# UNITED STATES PATENT AND TRADEMARK OFFICE

APPLICATION NO.	FILING DATE	FIRST NAMED INVENTOR	ATTORNEY DOCKET NO.	CONFIRMATION NO.
10/650,416	08/29/2003	David Edwin Zapp	DEZ 001 P2	6570

<b>Office Action Summary</b>	<b>Application No.</b> 10/650,416	<b>Applicant(s)</b> ZAPP, DAVID EDWIN	
	<b>Examiner</b> CARL D. PRICE	<b>Art Unit</b> 3749

Applicant - David E. Zapp  
Serial - 10/650,416  
Title - Charcoal Fire Starter and Cooking Device  
Docket No. DEZ 001 P2  
Sheet 2 of 4

FIG. 3

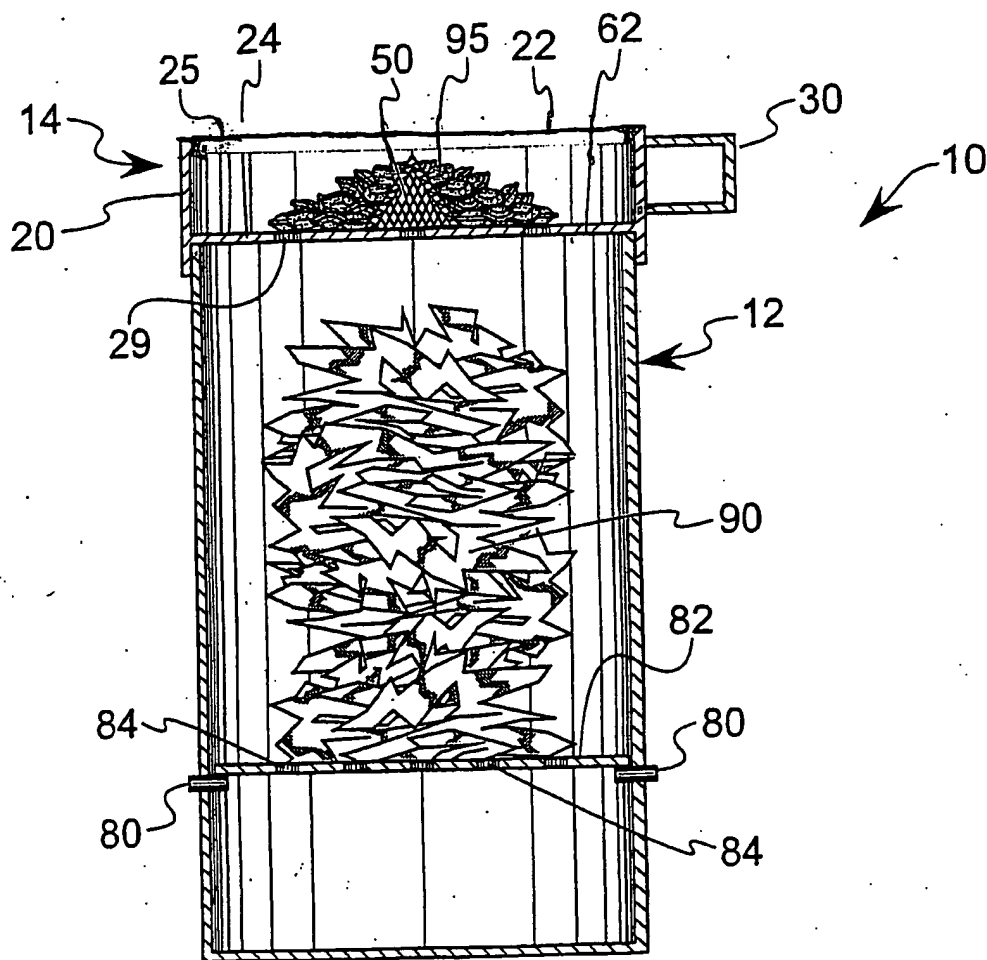
Approved  
2/23/06
